SUBJECT: Site Plan Review for 88 North Main Street

PC Case No: 2016-14

RE: PC 2016-14: Site Plan review for patio enclosure at 88 North Main Street

**Re:** **Keppers Tavern (Patio Enclosure)**

TITLE: PLOT PLAN - KEPNERS TAVERN

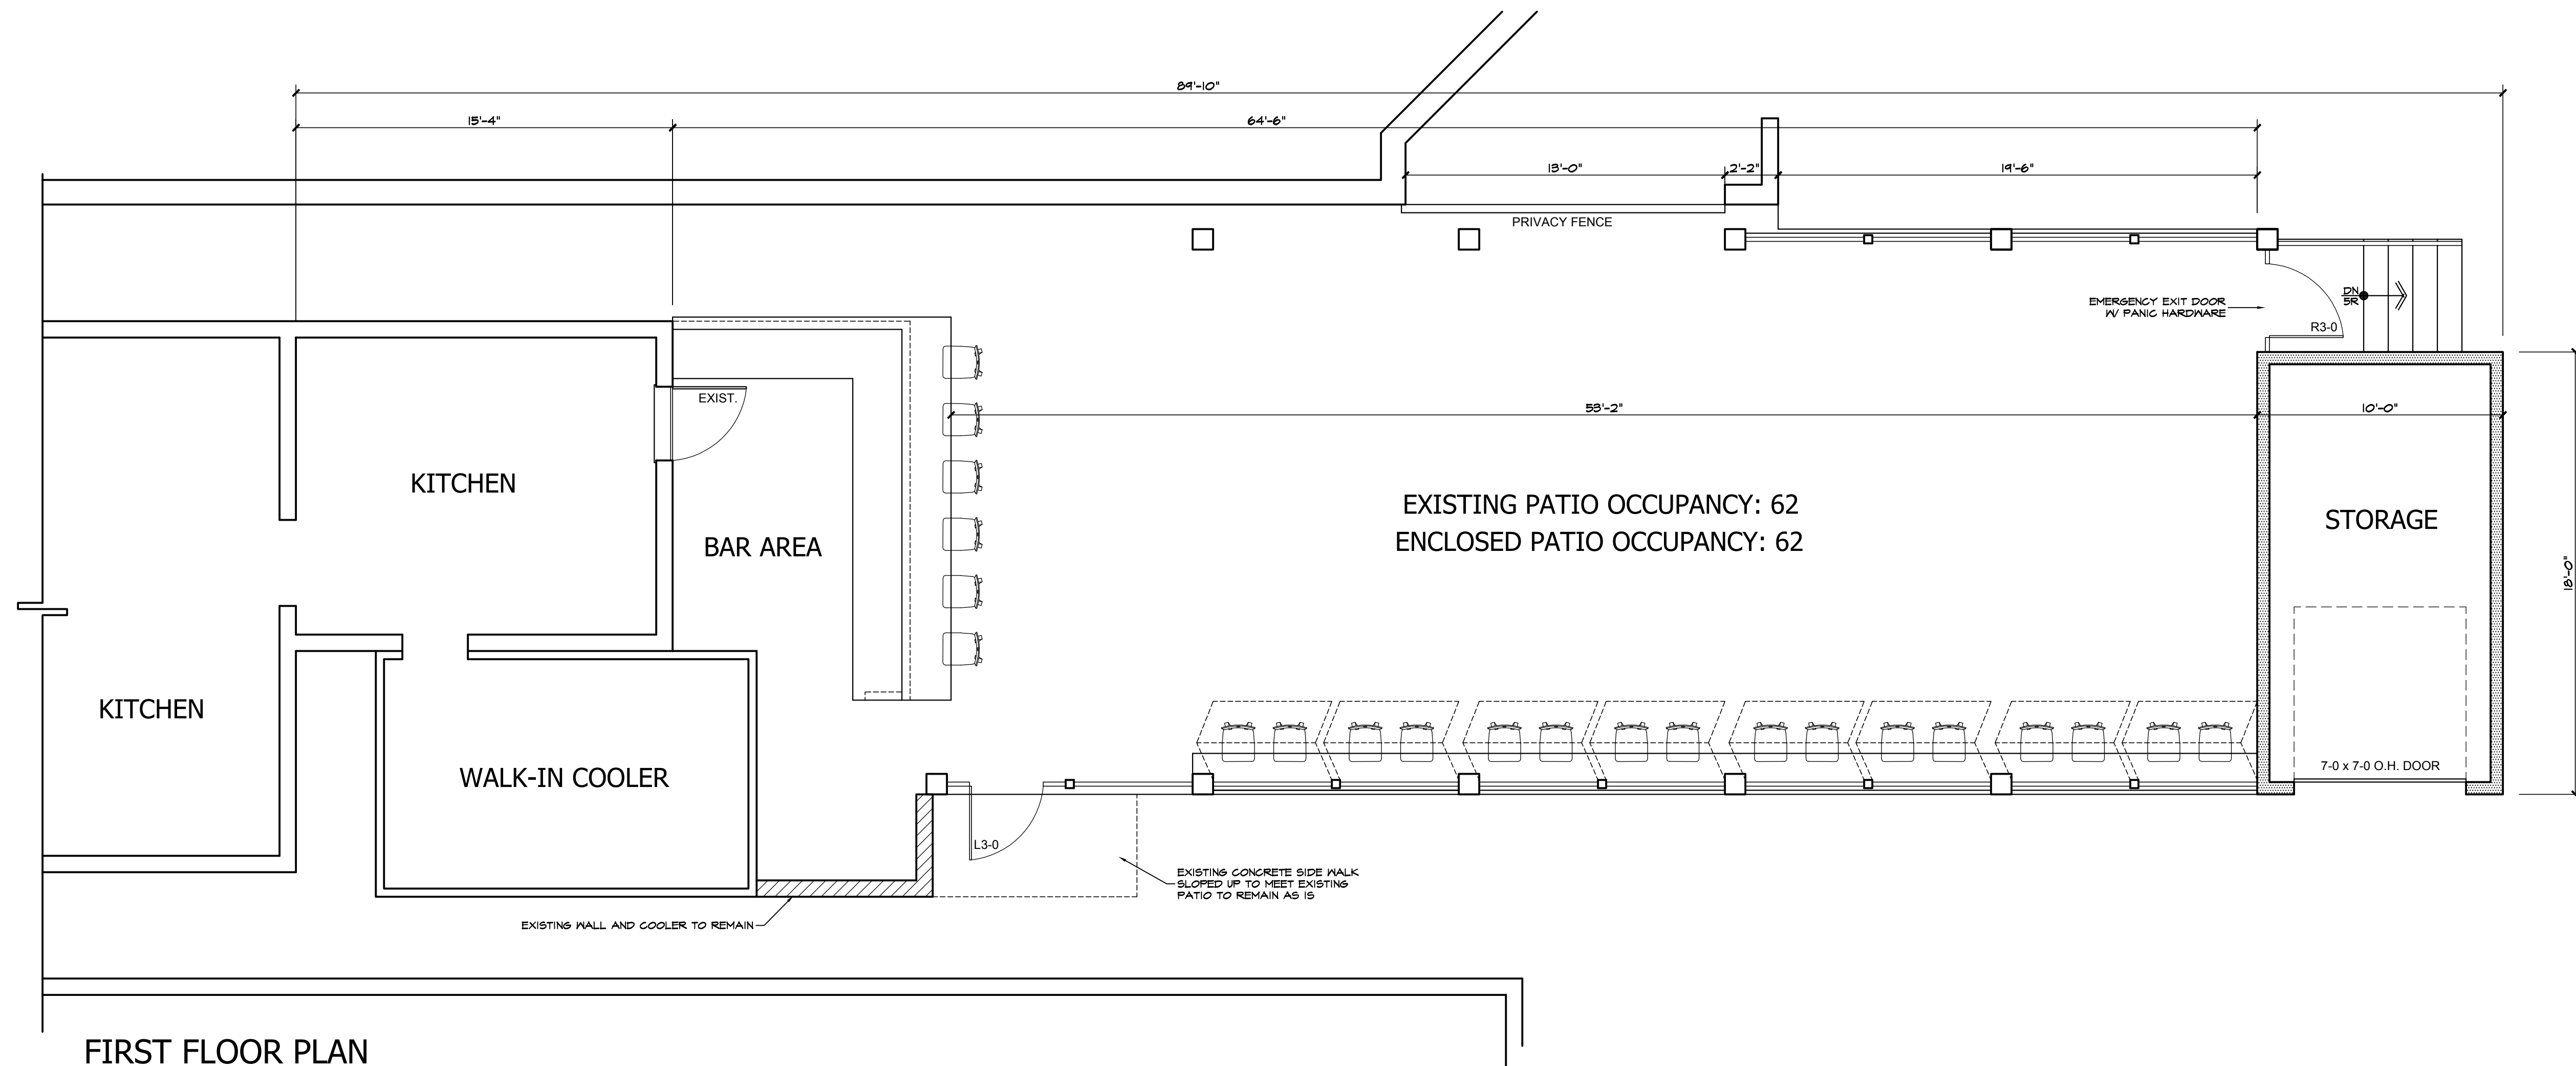
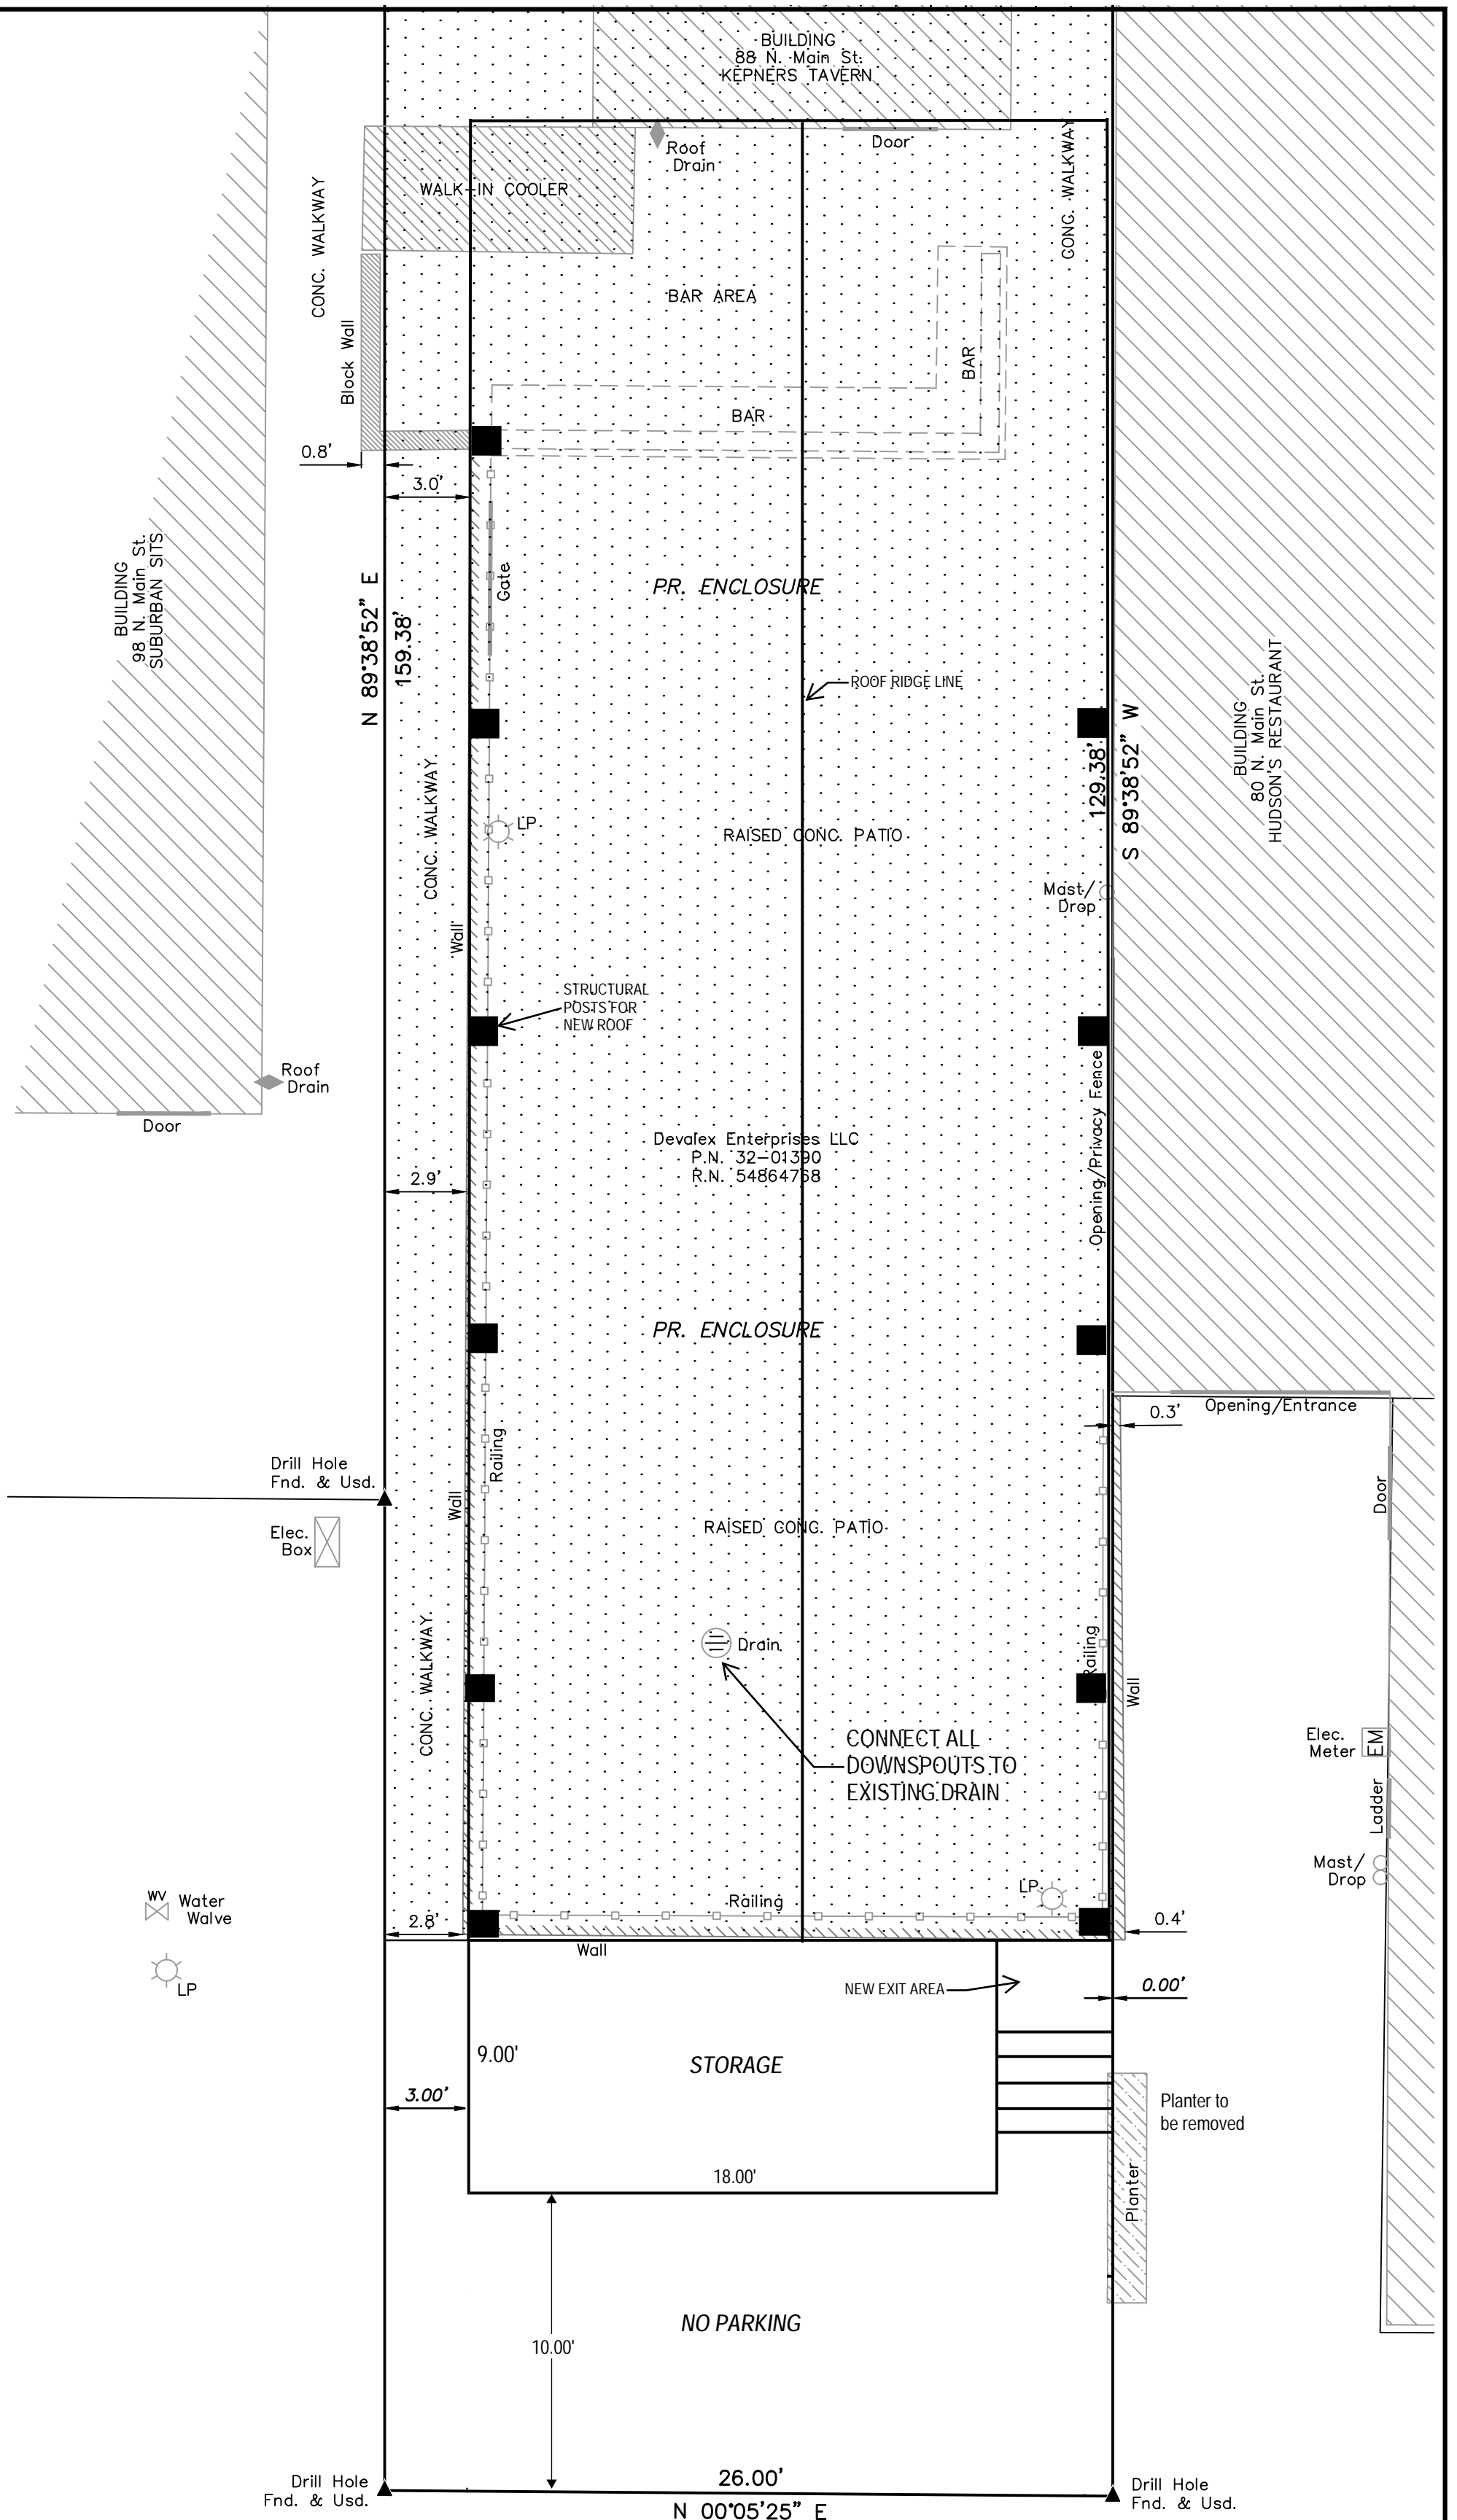
Setbacks: Minimum 10 foot rear yard and zero foot sideyard are required. The submitted boundary survey depicts portions of the existing improvements encroaching over the side property lines. All proposed improvements must be located on the subject property unless authorized by the adjacent property owner. The proposed access ramp north of the patio, the storage building, and the roof overhangs appear to encroach over the property lines. Staff additionally notes the proposed storage building does not meet the minimum 10 foot rear yard setback.

Information related to the existing and proposed seating capacity of the patio must be submitted. A private parking space is depicted to the west of the storage building; however, this area does not comply with applicable dimensional, screening, and access standards.

1. A site plan based on the boundary survey must be submitted.
2. The design must be revised so all proposed improvements are located on the subject property.
3. The storage building must be revised to comply with a 10 foot rear yard setback.

4. The proposed downspouts and their connection to the stormwater system have not been depicted on a site plan.
5. Information related to the existing and proposed capacity of the patio must be submitted.
6. Remove the private parking note as this area does not comply with applicable dimensional, screening, and access standards.
7. The existing shared parking easement must be updated to reflect the proposed improvements at the site.
8. A lighting plan, including a photometric layout and fixture cut sheets, must be submitted for any proposed exterior lighting.

1. Proposed roof and gutter along SW wall appears to be encroaching upon private property. Provide an easement or remove encroachment.
2. Show tie-in of roof drains into existing storm sewer system that current floor drain on patio discharges into.
3. Dimensional differences between "Plot Plan" and Architectural Drawing.
  - a. Proposed Storage unit is shown 14ft wide on architectural dwg. And 12ft on "Plot Plan"
  - b. Proposed parking is shown on "plot Plan" not on architectural dwg.

**Engineering:** City Engineer Thom Sheridan has submitted a review letter dated May 18, 2016. Mr. Sheridan indicates the need to connect the downspouts to the existing floor drain and remove the proposed roof overhang encroachments. The revised plans on June 1, 2016 address the above comments and have been forwarded to the Engineering Department for review.
